9762 – Former Mather & Platt Foundry, Grimshaw Lane, Manchester, M40 2BA

Planning Application Reference: 129444/FO/2021

Please find a response to planning condition 13 below.

Further to the above please see below a reply to the comments dated 25th of September 2024 on the information previously submitted to discharge this condition:

DRAWING No 9762-PTA-XX-XX-DR-C- 8100

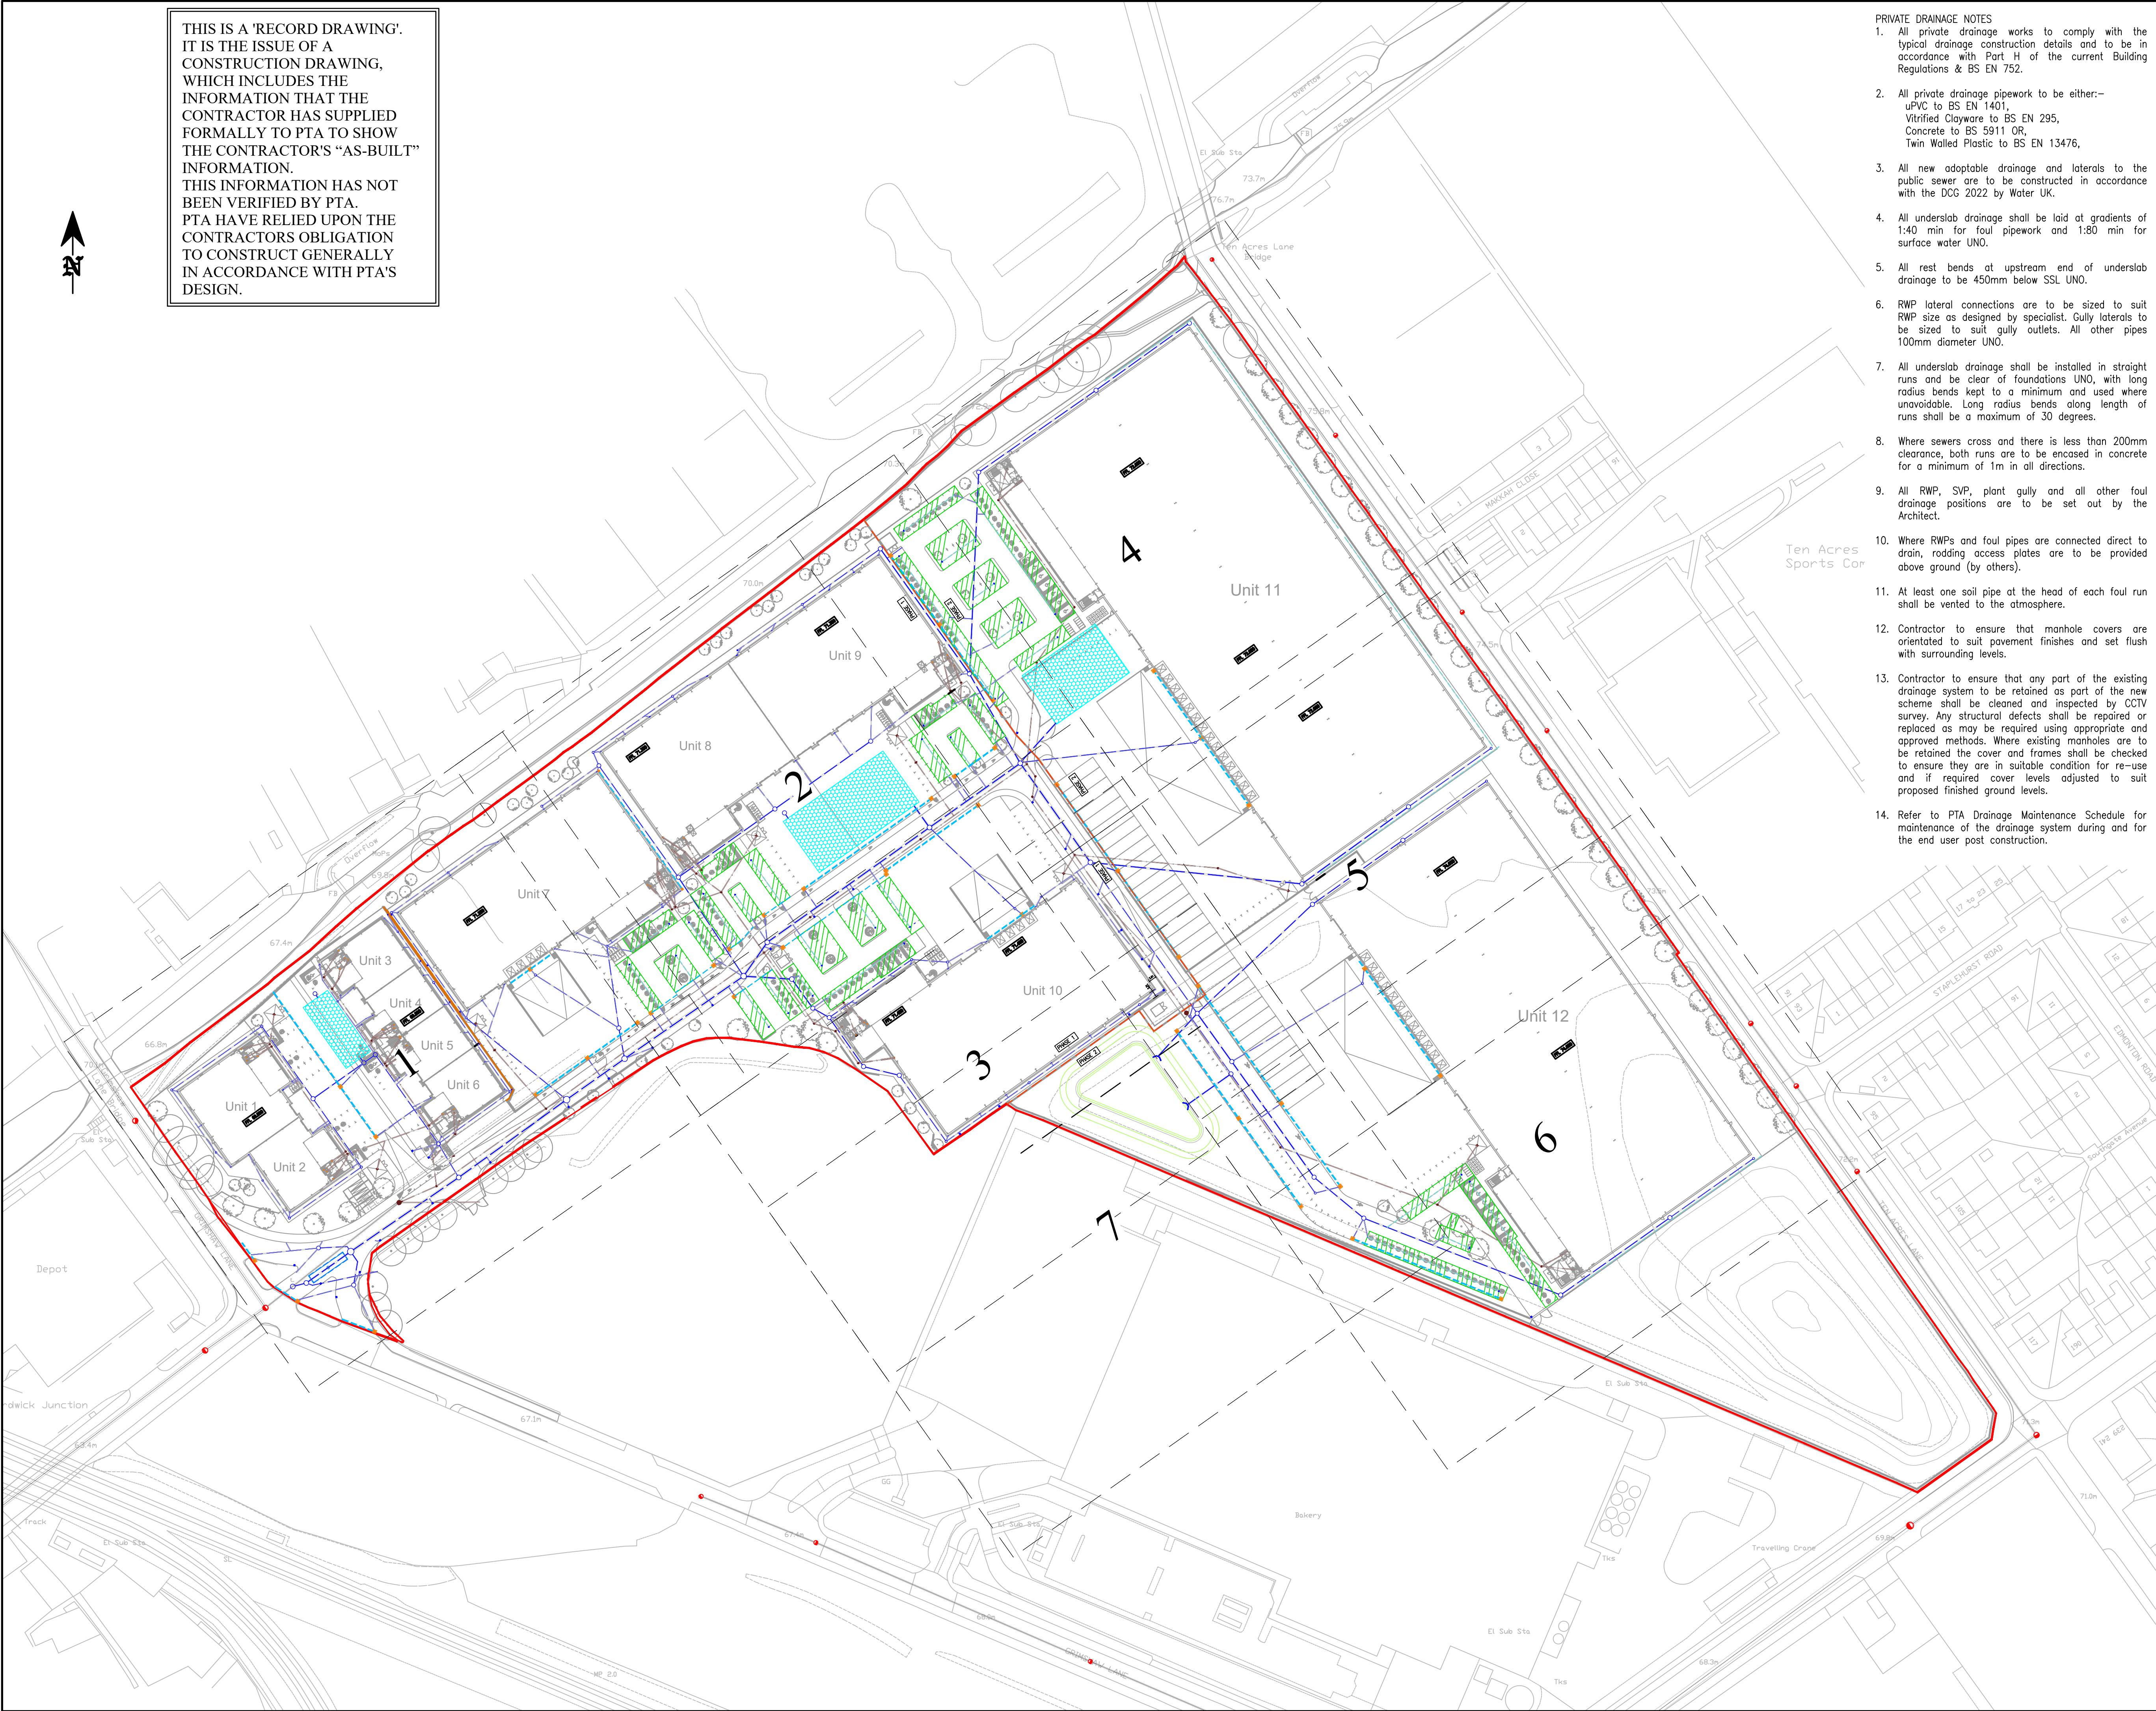
-The latest engineering drawing no. 9762-PTA-XX-XX-DR-C-8101 now indicates a section of the 375mm combined sewer to be 'abandoned / removed' and it has been confirmed this to be private network. Evidence of any investigation to confirm this section is 'redundant' is required. Any existing connections will need to be accommodated (if identified).

- Microdrainage calculations results now include a manhole schedule and a layout plan with relevant pipe and manhole references.
- This section of the 375mm diameter combined sewer was a private drain that previously drained the site. During demolition all laterals were surveyed and no connections to 3rd party areas were encountered. During construction this section of drain has been removed, and as such we have now removed it from the record drawings. Updated drawings are attached for reference.
